Curve fitting to  
Petar Pepeljugoski's  
modal noise simulations,  
supporting P802.3cm d2.0 comment 38

Paul Kolesar – CME Consulting, affiliated with CommScope

IEEE P802.3cm meeting, Salt Lake City, UT

# Curve fits to Petar's Modal Noise sims for MPNk = 0.1

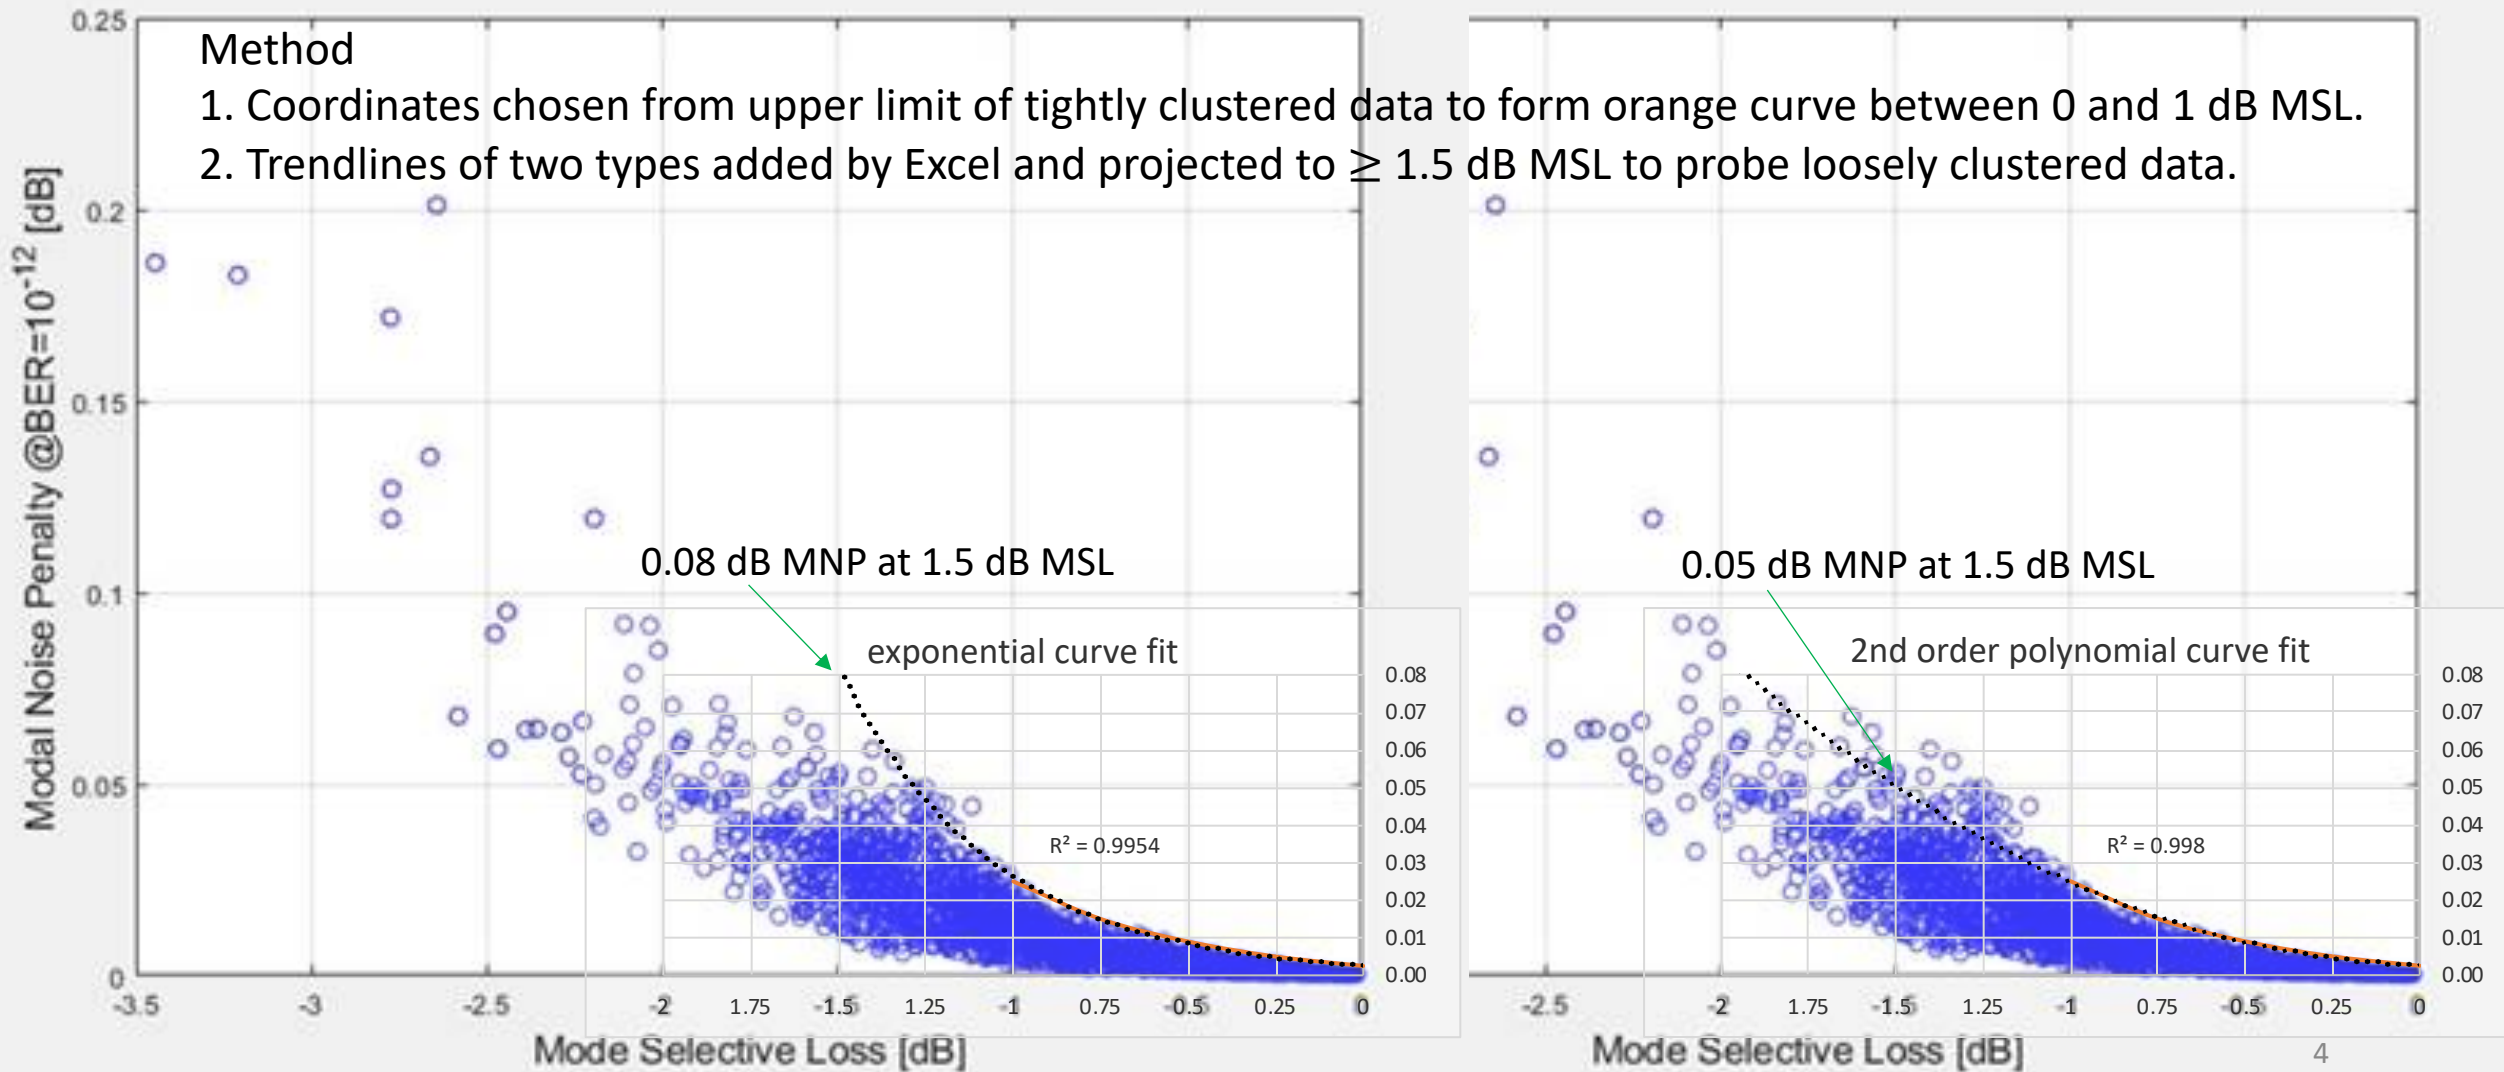
# Observations

- The polynomial fit (right graph) excludes some data points, but has slightly superior curve fit,  $R^2 = 0.998$ , compared to the exponential curve fit,  $R^2 = 0.995$ .
- The exponential curve fit (left graph) encompasses nearly all data, but is on a trajectory that appears unrealistically severe.

- Use the polynomial curve fit to estimate the MNP at 1.5 dB MSL.
- Multiply its projected 0.05 dB MNP by the factor of 3.8 from the king contribution to allocate 0.19 dB for modal noise penalty of 400GBASE-SR4.2. This rounds to 0.2 dB of additional power budget.
- Change the Tx and/or Rx specifications in tables 150-7 and/or 150-8 to deliver the additional power budget.
- Reflect these changes in informative table 150-9 regarding the cable.
- Comment 38 has been submitted on draft 2.0 to this effect.
